A REPAIR

## ON-SITE SEWAGE DISPOSAL SYSTEM HOWARD COUNTY HEALTH DEPARTMENT BUREAU OF ENVIRONMENTAL HEALTH

ADDRESS: 3356 Brantly Road PROPERTY OWNER: M. Pedrotti-Krueger

**TRENCH DATA**

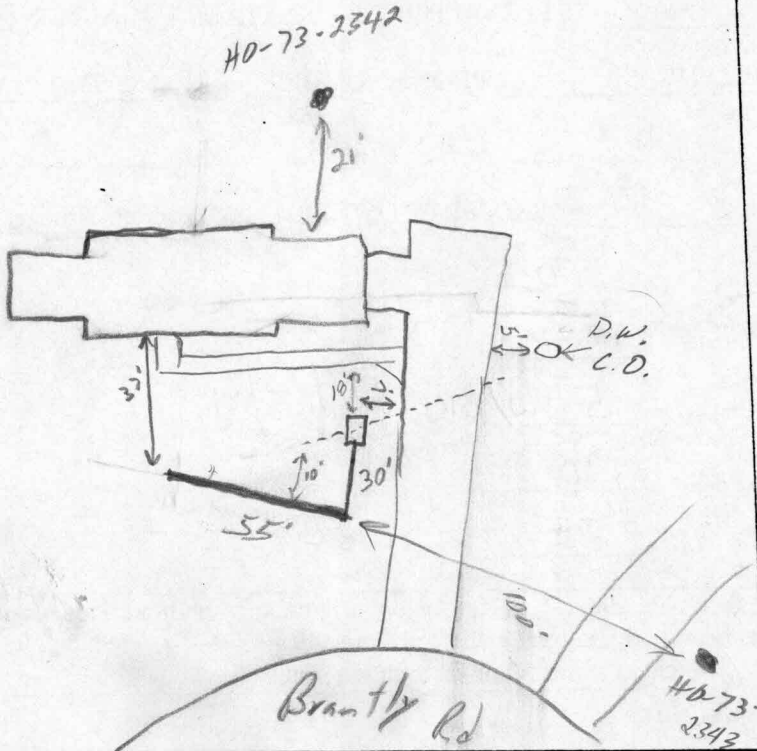
INSPECTION COMMENTS: 3/14/02 Trench 2/3 installed. Soil appears consistent to 9.5' - Lt orange-brown sandy loam (SC) Existing trench appears to be off contour (SC)
